NUMBER: 07-002-13

Coolant Weepage At EGR Hose

This bulletin involves replacing the EGR hose.

Chrysler 300 (International Only)

Fig. 1 EGR

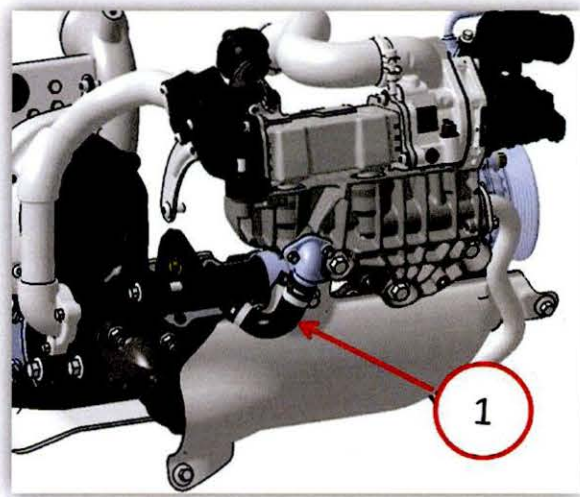
The EGR hose may weep coolant.

1. Drain the cooling system. Follow the detailed procedures available in DealerCONNECT/TECHCONNECT, Refer To 07 - Cooling - Standard Procedure.
2. Lower the belly pan splash shield.
3. Lower the rear transmission splash shield.
4. Replace the EGR coolant hose.

1 - EGR Coolant Hose
